**RE: STOWE AT 7-BAR NORTH SUBD (A-13/D7B)
ENGINEERS RECERTIFICATION FOR LOTS 9 THRU 13
ENGINEERS STAMP DATED 7/7/1995
ENGINEERS CERTIFICATION DATED 4/21/1997 Rev. 12/11/2001**

Re: Stowe at Seven Bar North Subdivision – Grading and Drainage Plan (A13/D7B)

STOWE AT SEVEN BAR NORTH
FINAL GRADING PLAN - STOWE

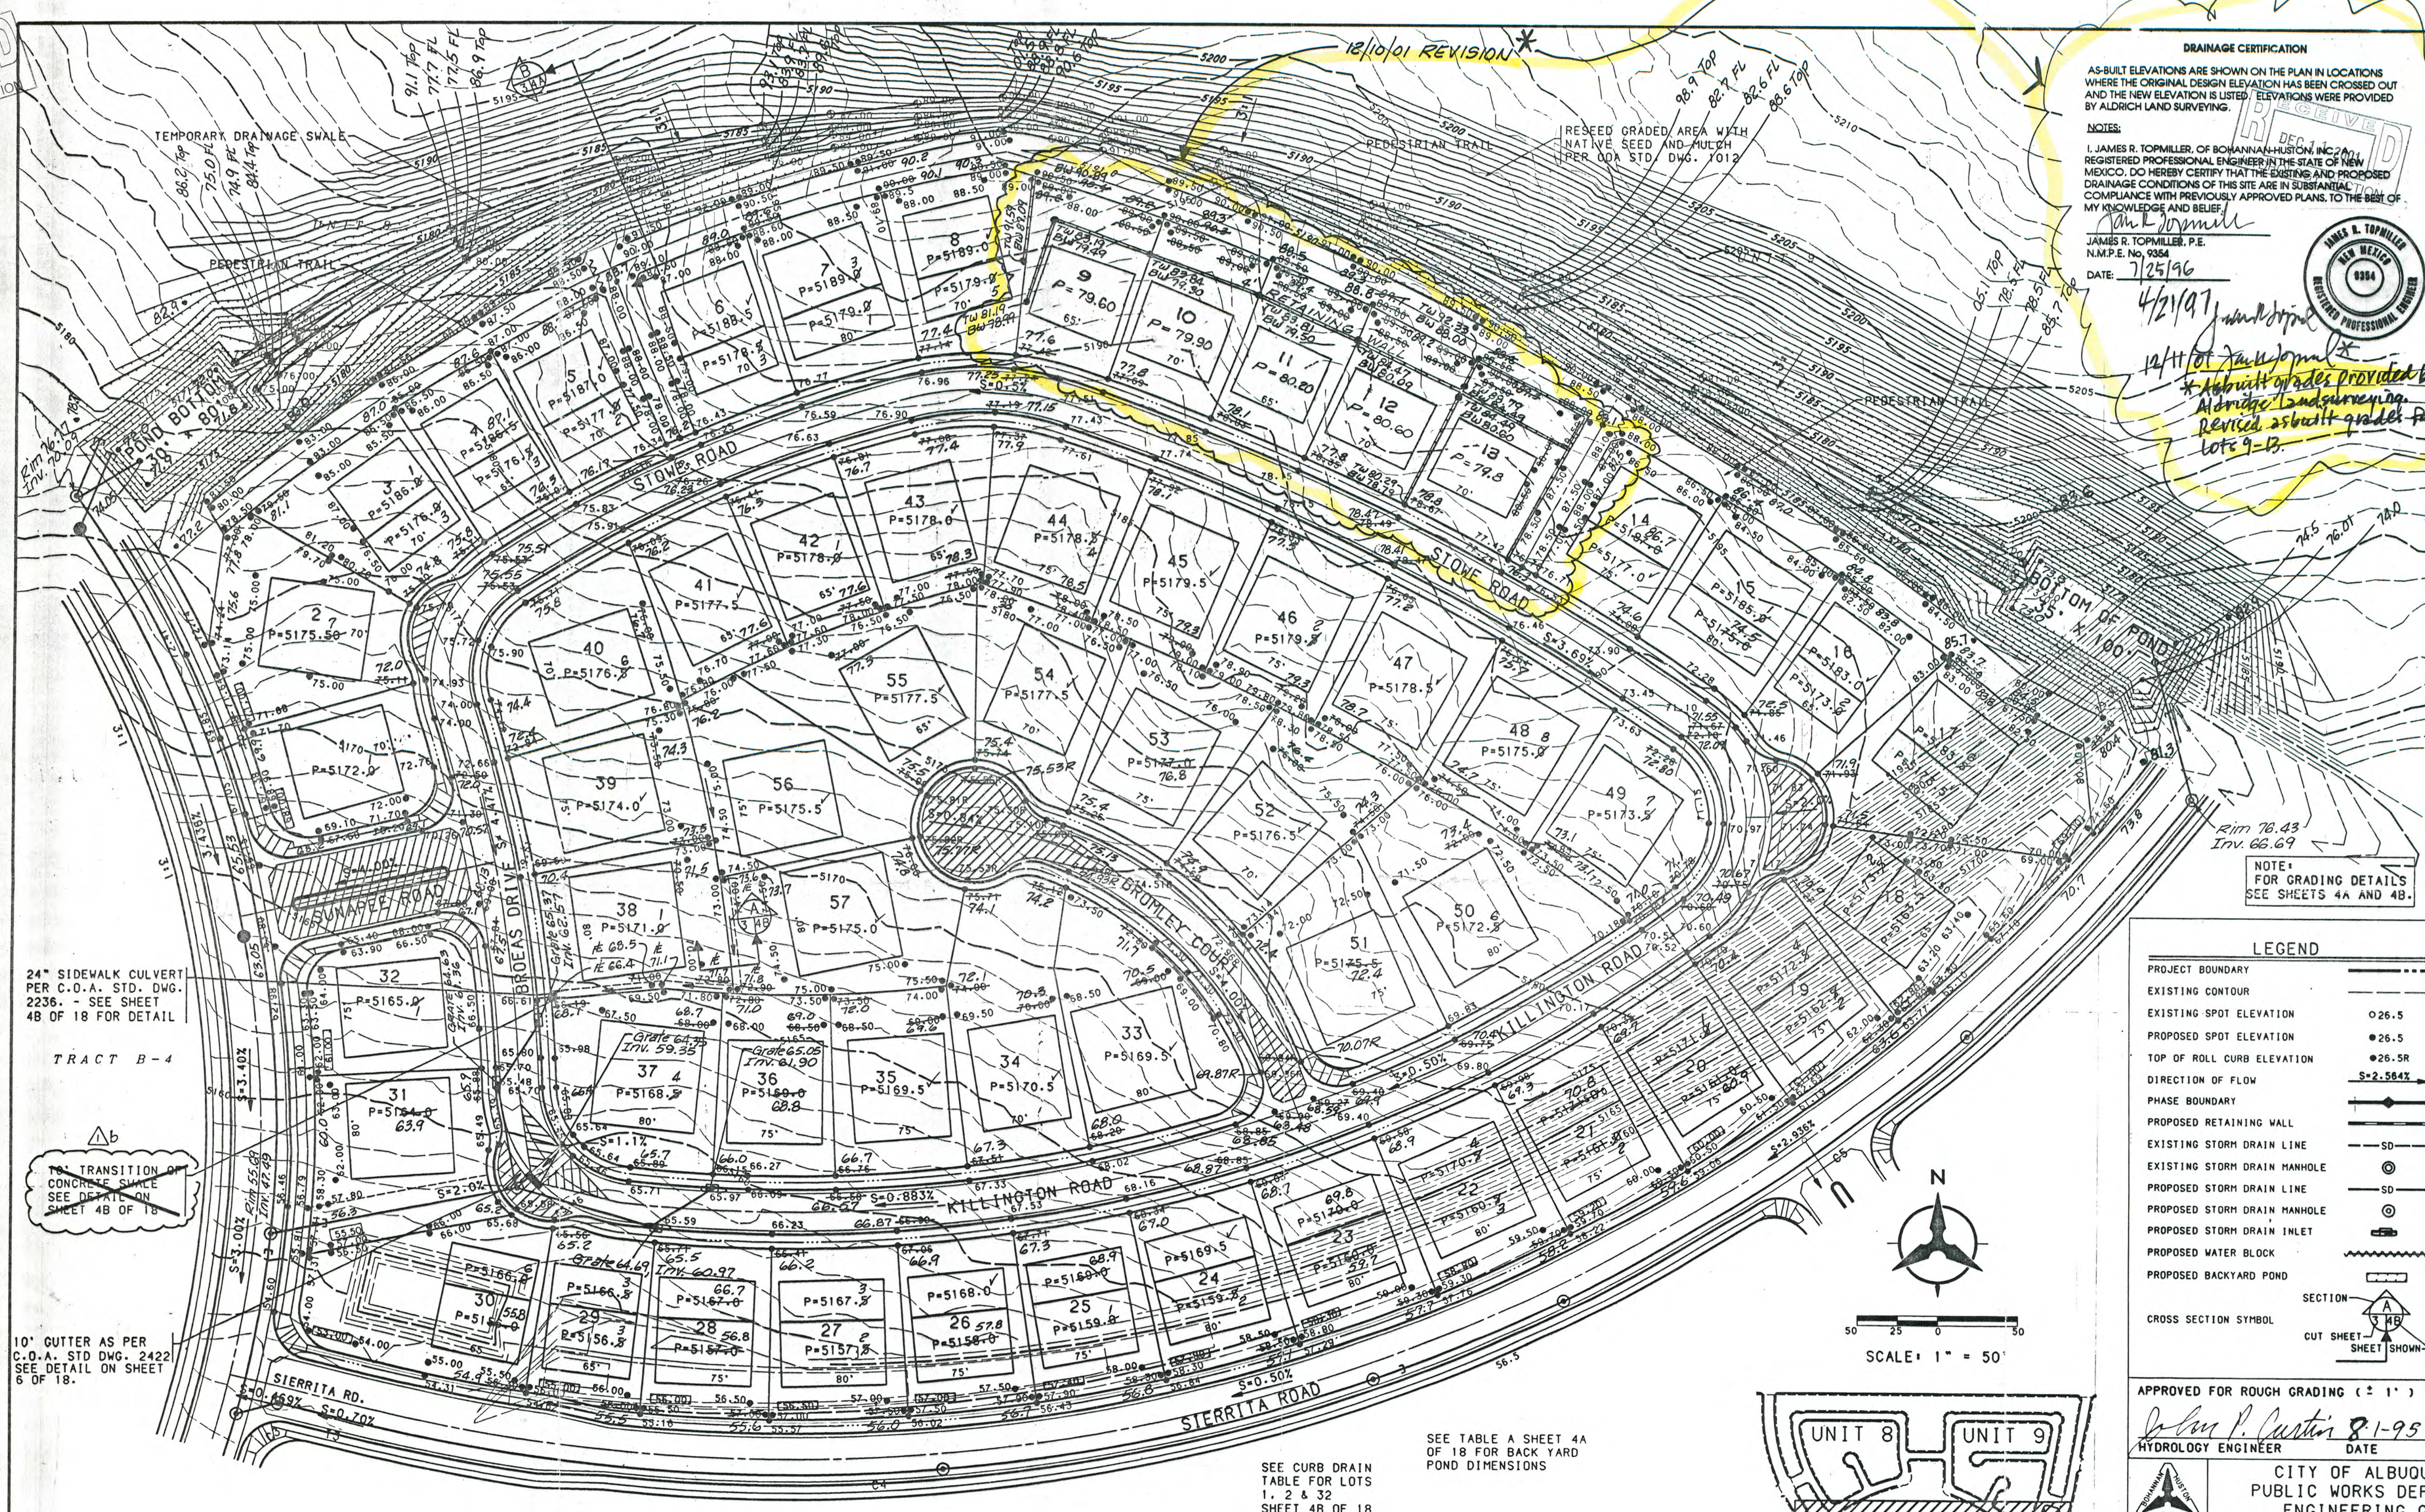
This letter is to notify you that grading on several vacant lots in the referenced subdivision has been modified from the original approved and certified plan. The lots are Lot 9 thru Lot 13 of the referenced subdivision, located on the north side of Stowe Rd..

City Ordinance requires that grade changes in excess of 1.5 feet from the original plan need to be approved by DRB as an Ammended Grading and Drainage Plan. Until an ammended plan is approved, Building Permits and/or Certificates of Occupancy cannot be issued for these lots.

Please file for appropriate review and approval as soon as possible. If you have questions, contact me at 942-3980.
